NLT Product Change Notice
PCN Tracking Number: NLT-PP-5062
 (The schedule is revised from NLT-PP-4963)

12.1" XGA

NL10276BC24-21, NL10276BC24-21F, NL10276BC24-21L

Fig.1 Image of backlight (optical sheet) change

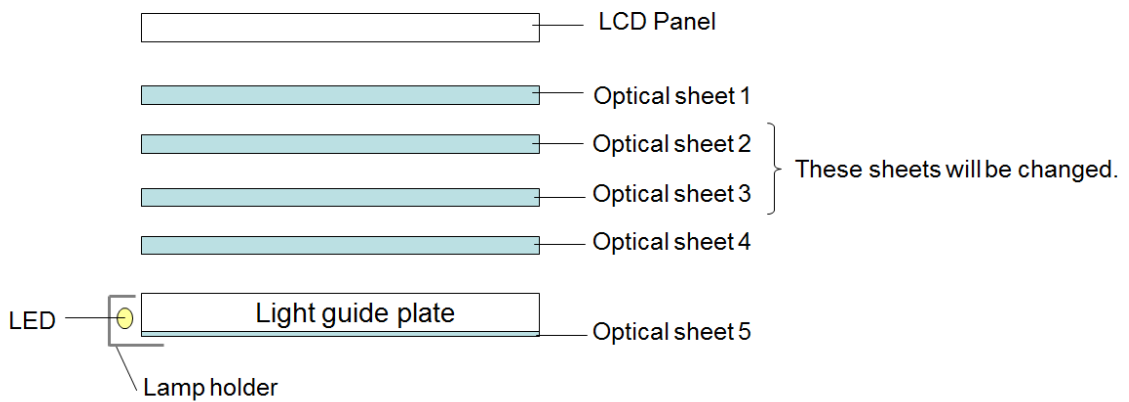
Item	Description of the change
Backlight (Optical sheet)	Due to discontinuation of optical sheet in the backlight, the optical sheet in the backlight will be changed. (See Fig.1.)

There are no optical, electrical or mechanical specifications change and no changes in product reliability. And, there will be no influence on UL approval and RoHS compliance.
